UNITED STATES PATENT AND TRADEMARK OFFICE

APPLICATION NO.	FILING DATE	FIRST NAMED INVENTOR	ATTORNEY DOCKET NO.	CONFIRMATION NO.
10/618,689	07/09/2003	Robert L. Doubler	2131.000019	8552
43541 7590 02/27/2007 WOOD, HERRON & EVANS (ZIMMER SPINE) 2700 CAREW TOWER 441 VINE STREET CINCINNATI, OH 45202			EXAMINER REESE, DAVID C	
			ART UNIT	PAPER NUMBER
			3677

Office Action Summary	Application No.		Applicant(s)	
	10/618,689		DOUBLER ET AL.	
	Examiner		Art Unit	
	David C. Reese		3677

DETAILED ACTION

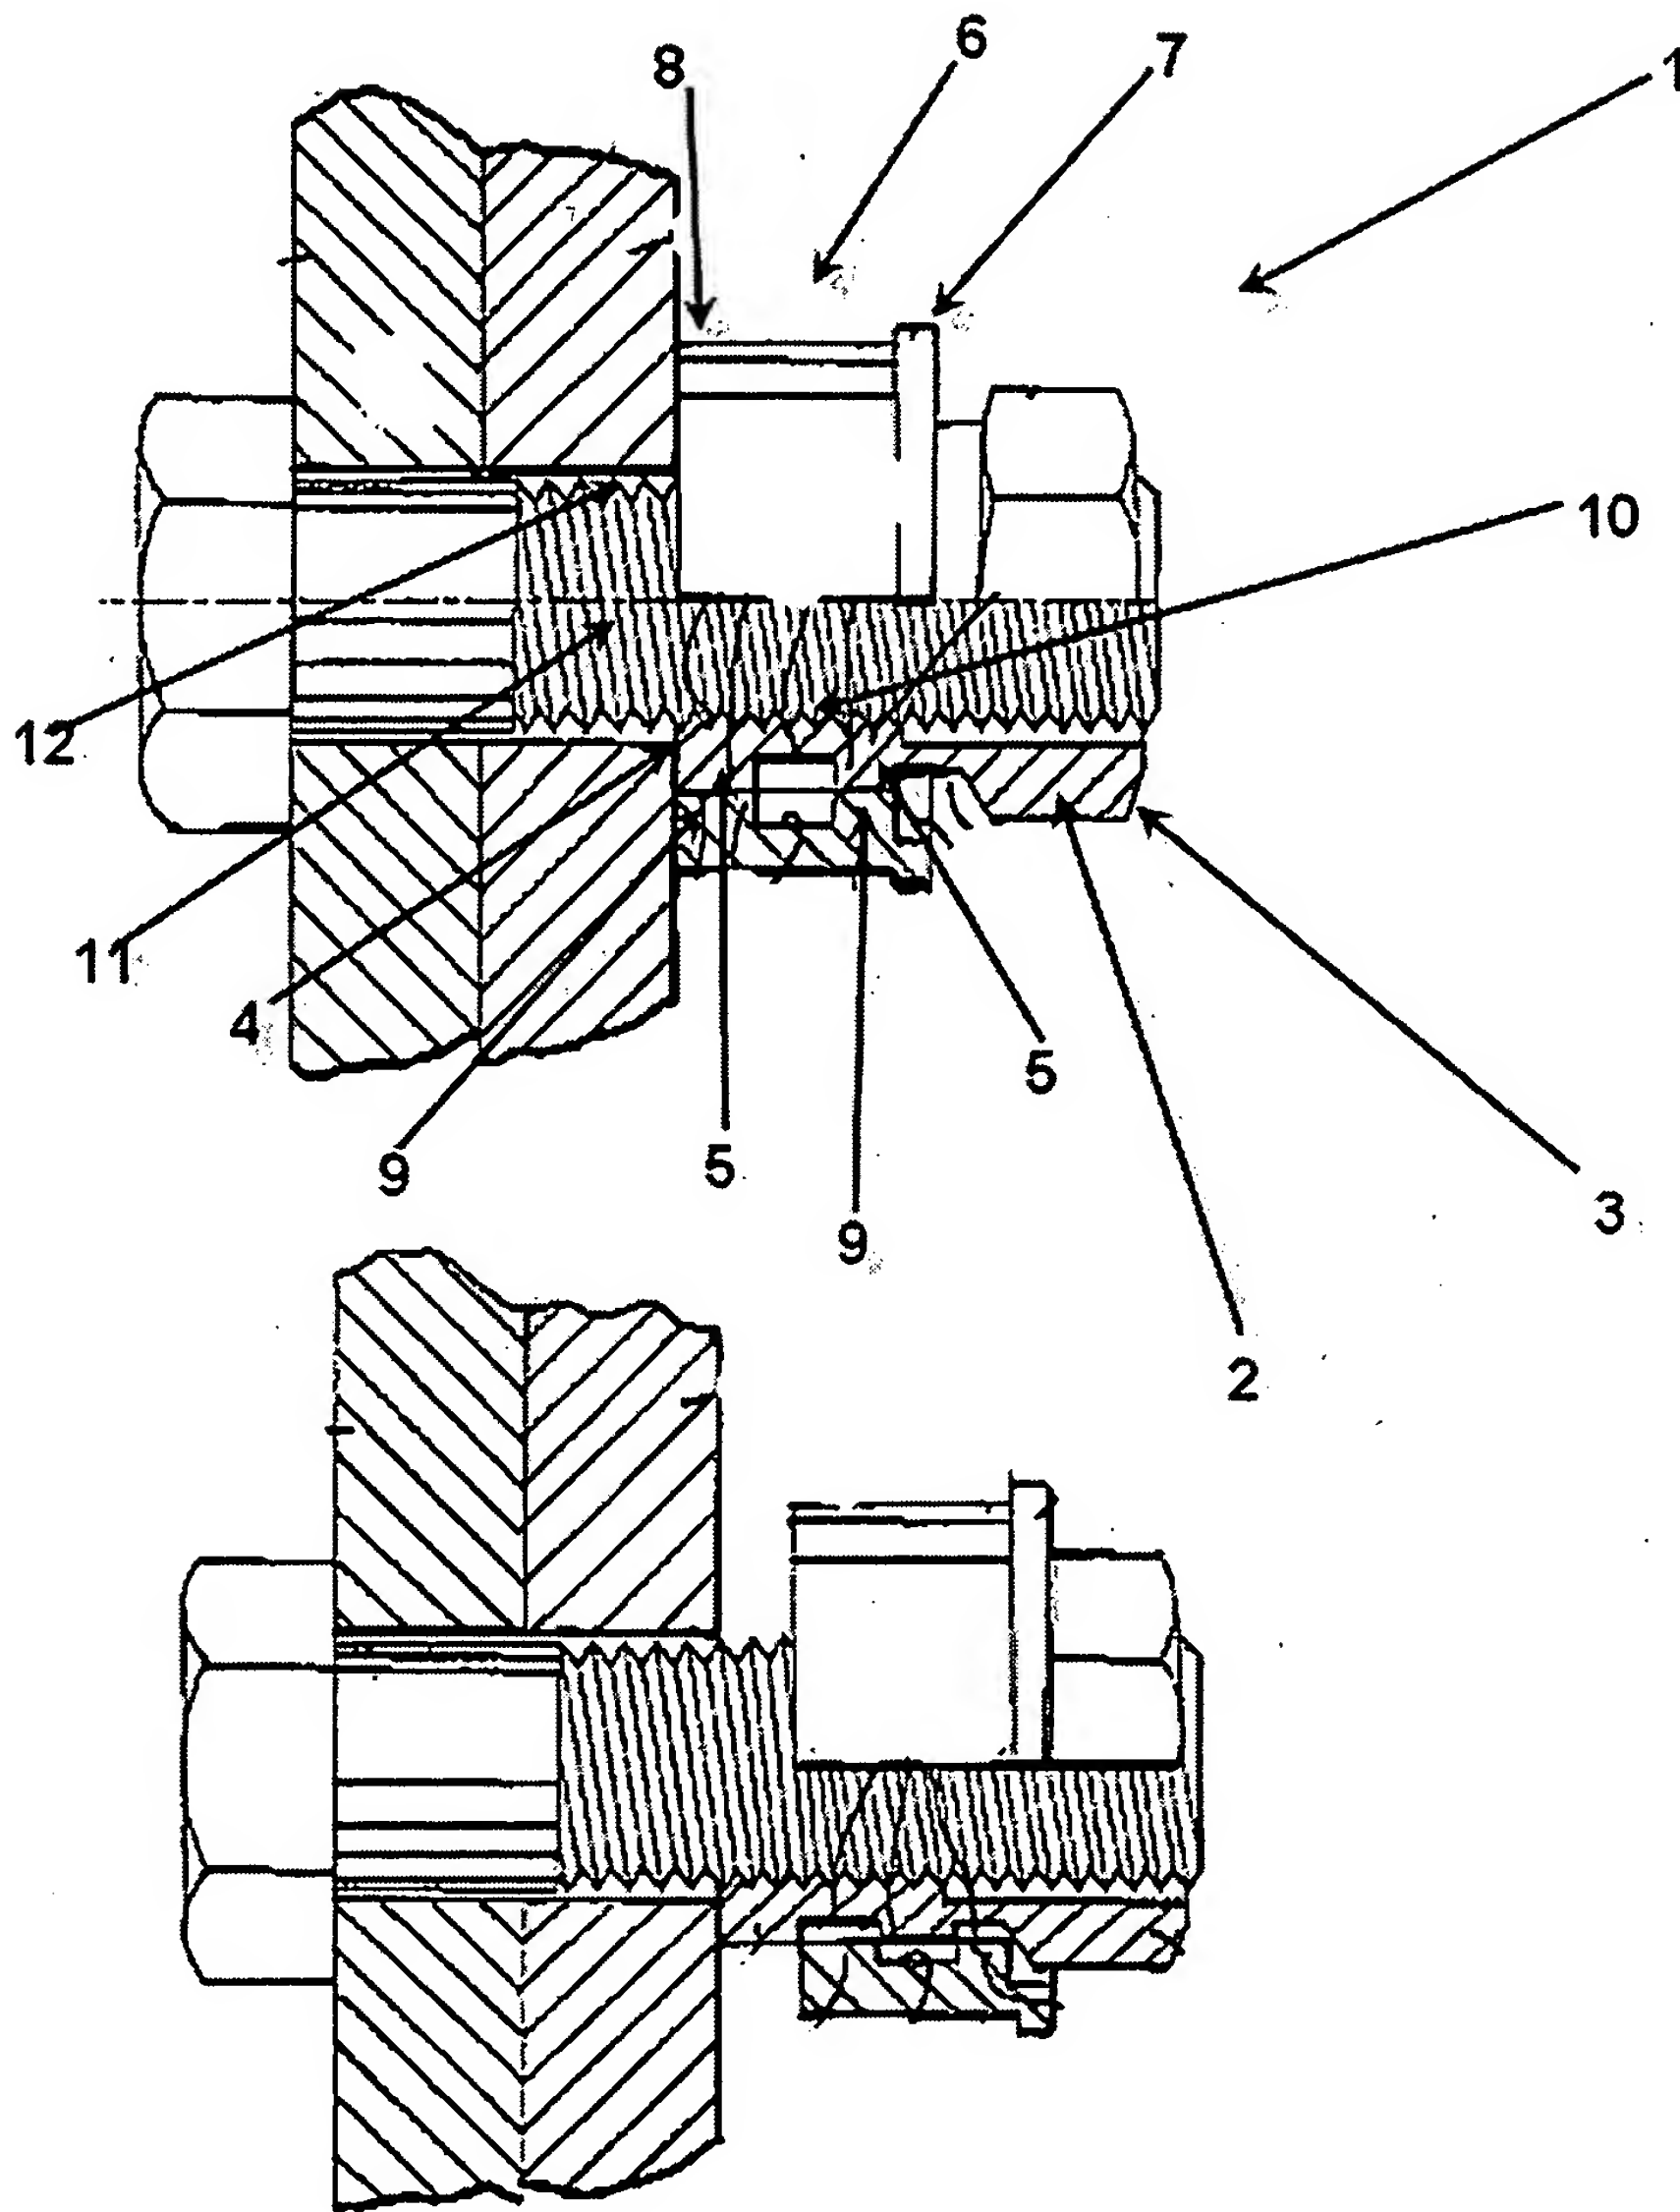
As for Claim 1, Batten discloses a linear fastener system (1) (see figure below) comprising:

a collet member (2) having a base end (4), a top end (3), an inner engaging surface (10), and an outer ribbed surface (5) positioned about a central axis;

a compression ring member (6) having a base end (8), a front end (7), an inner ribbed surface (9) having at least one radially inwardly extending rib (9), and an outer surface (6) positioned about a central axis;

said inner ribbed surface (9) of said compression ring member (6) being constructed and arranged for coaxial alignment and overlapping engagement with respect to said outer ribbed surface (5) of said collet member (2), said compression ring member (6) non-rotationally linearly traversable with respect to said outer ribbed surface (5) of said collet member (2) between a first release position (bottom figure) and a second engaged position (top figure), wherein said engaged position (top figure) results in said outer ribbed surface (5) of said collet member (2) and said inner ribbed surface (9) of said compression ring (6) compressing said collet member (2) and tensilely loading said compression ring (6) member to engage a shank member (11) having an outer gripping surface (12) [whereby said collet member (2) is clamped to the shank member (11) without rotating said collet member (2)], and wherein said release position (bottom

figure) results in expansion of said collet member (2) thereby releasing the outer gripping surface (12) of the shank member (11).

Examiner's note: the above statement in brackets is an example of intended use language; language that in the instant case fails to further limit the structure of the claimed invention. The prior art only needs to be capable of performing said function to be anticipatory, and in the instant case, the collet member of Batten is capable of being clamped to the shank member without rotating said collet member and thus remains anticipatory towards that of the claimed invention. It has been held that a recitation with respect to the manner in which a claimed apparatus is intended to be employed does not differentiate the claimed apparatus from a prior art apparatus satisfying the claimed structural limitations. *Ex parte Masham*, 2 USPQ2d 1647 (1987).

Re: Claim 17, wherein said outer ribbed surface (5) of said collet member (2) and said inner ribbed surface (9) of said compression ring member (6) are constructed and arranged to maintain an axially aligned interfitting relationship in said release position (bottom figure).

As for Claim 26, Batten discloses a linear fastener system (1) (see figure above) comprising:

a collet member (2) including an outer ribbed surface (5) defining peaks and valleys, and an inner surface (10) adapted to grip a corresponding surface (12) of a shank (11) in a locked condition of said fastener system (see figure above) and

a compression ring (6) including an inner ribbed surface (9) defining peaks and valleys corresponding to said peaks and valleys (5) of said collet member (2);

the linear fastener system having a locked condition (top surface) wherein said peaks of said collet member (2) and said peaks of said compression ring (6) are in confronting alignment, and an unlocked condition (bottom figure) wherein said peaks of said collet member (2) are

disposed in said valleys of said compression ring (6), whereby said collet member (2) [may be clamped to the shank (11) in said locked condition without rotating said collet member (2)].

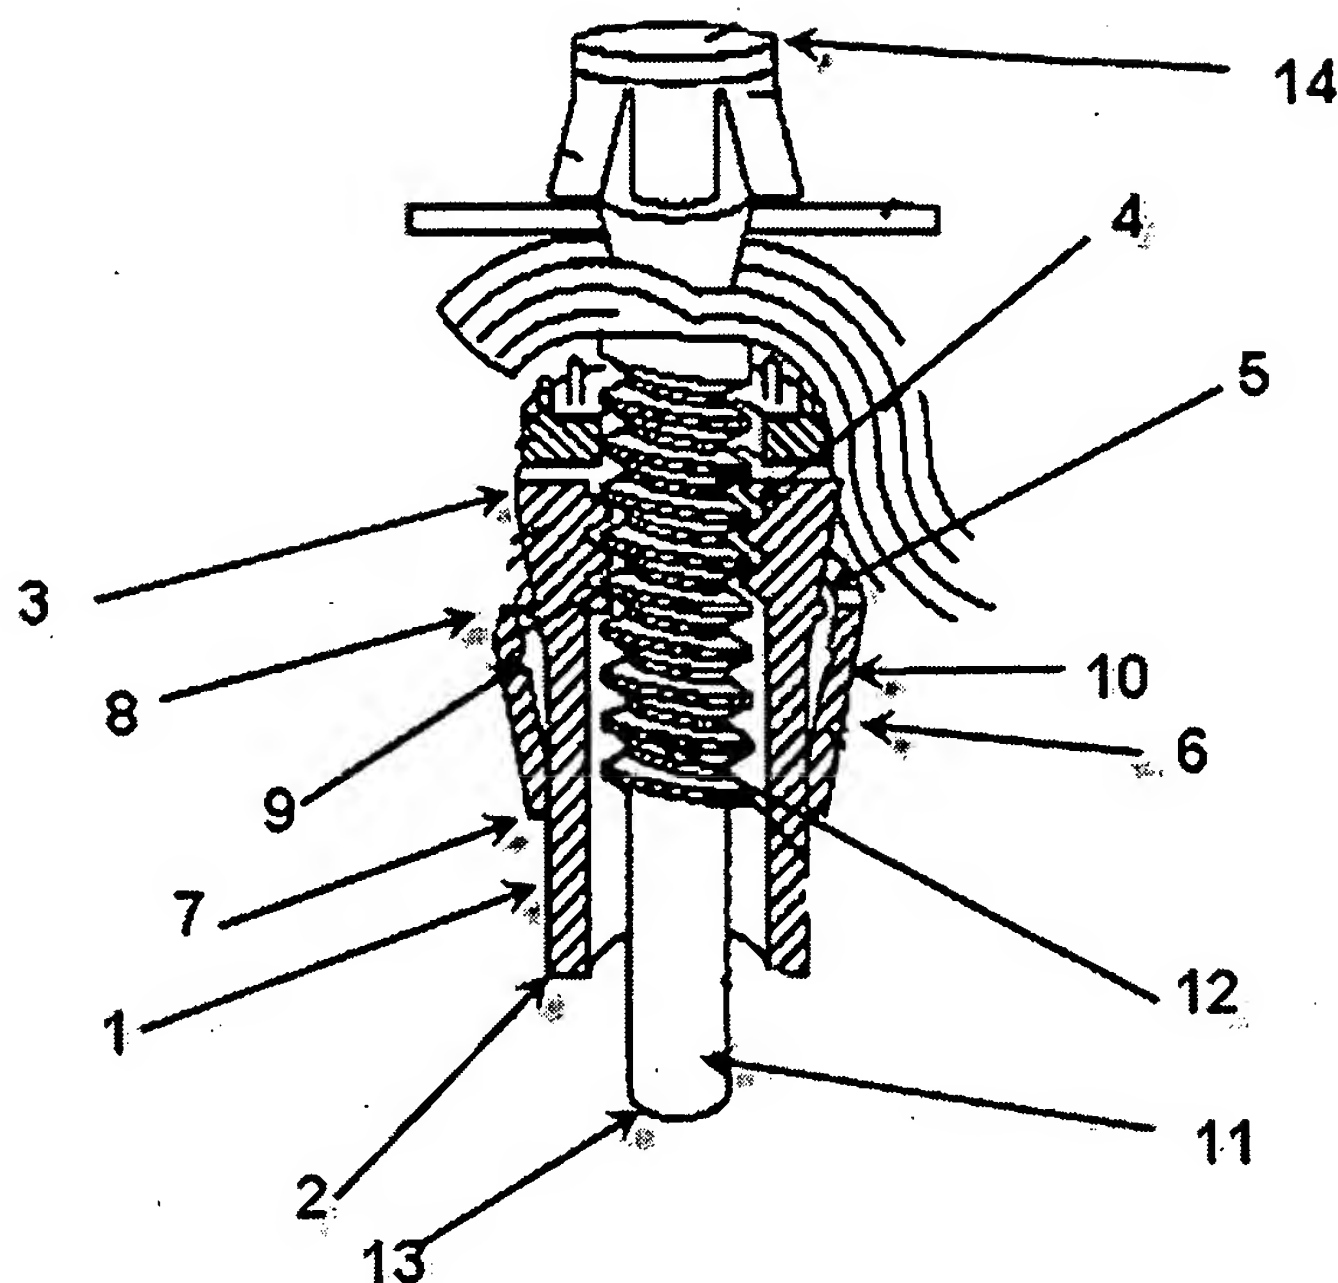
As for Claim 1, Freedland et al. discloses a linear fastener system (see figure below) comprising:

a collet member (1) having a base end (2), a top end (3), an inner engaging surface (4), and an outer ribbed surface (5) positioned about a central axis;

a compression ring member (6) having a base end (7), a front end (8), an inner ribbed surface (9) having at least one radially inwardly extending rib (9), and an outer surface (10) positioned about a central axis;

said inner ribbed surface (9) of said compression ring member (6) being constructed and arranged for coaxial alignment and overlapping engagement with respect to said outer ribbed surface (5) of said collet member (1), said compression ring member (6) non-rotationally linearly traversable with respect to said outer ribbed surface (5) of said collet member (1) between a first release position and a second engaged position, wherein said engaged position results in said outer ribbed surface (5) of said collet member (1) and said inner ribbed surface (9) of said compression ring (6) compressing said collet member (1) and tensilely loading said compression ring (6) member to engage a shank member (11) having an outer gripping surface (12) whereby said collet member (2) is clamped to the shank member (11) without rotating said collet member (2), and wherein said release position results in expansion of said collet member (1) thereby releasing said outer gripping surface (12) of said shank member (11).

Re: Claim 2, wherein said shank member (11) includes a first end (14) and a second end (13).

Re: Claim 3, wherein said ribbed outer surface (5) of said collet member (1) includes at least one outwardly and circumferentially extending rib (5), each said rib including a first ramp surface to facilitate coaxially aligned linear overlapping movement of said compression ring (6) in relation to said collet member (1) for engagement thereof, and a second ramp surface to facilitate linear removal of said compression ring (6) from said collet member (1).

Re: Claim 4, wherein said inner engaging surface (4) of said collet member (1) is constructed and arranged with a conjugate shape in relation to said outer gripping surface (12) of said shank member (11).

Re: Claim 5, wherein said inner engaging surface (4) of said collet member (1) constructed and arranged with internal threads (4).

Re: Claim 10, wherein said first end (14) of said shank member (11) includes a tensioning means (111E1 in Fig. 43), said tensioning means (111E1 in Fig. 43) being constructed and arranged to allow said shank member (11) to be tensilely loaded (via 6) prior to linear traversal of said compression ring member (6) into said engagement position with respect to said collet member (1).

Re: Claim 13, wherein said shank member tensioning means (111E1 in Fig. 43) includes at least one internal bore (111E1 in Fig. 43) extending inwardly from said first end of said shank member (14 in view of 111E1 in Fig. 43) along the longitudinal centerline of said shank member (11), wherein said at least one internal bore (111E1 in Fig. 43) is constructed and arranged for gripping and placing a tensile load (via 6) on said shank member (11) prior to linear traversal of said compression ring member (6) into said engagement position with respect to said collet member (1).

Re: Claim 17, wherein said outer ribbed surface (5) of said collet member (1) and said inner ribbed surface (9) of said compression ring member (6) are constructed and arranged to maintain an axially aligned interfitting relationship in said release position (with compression member (6) near the bottom of said collet member, (1)).
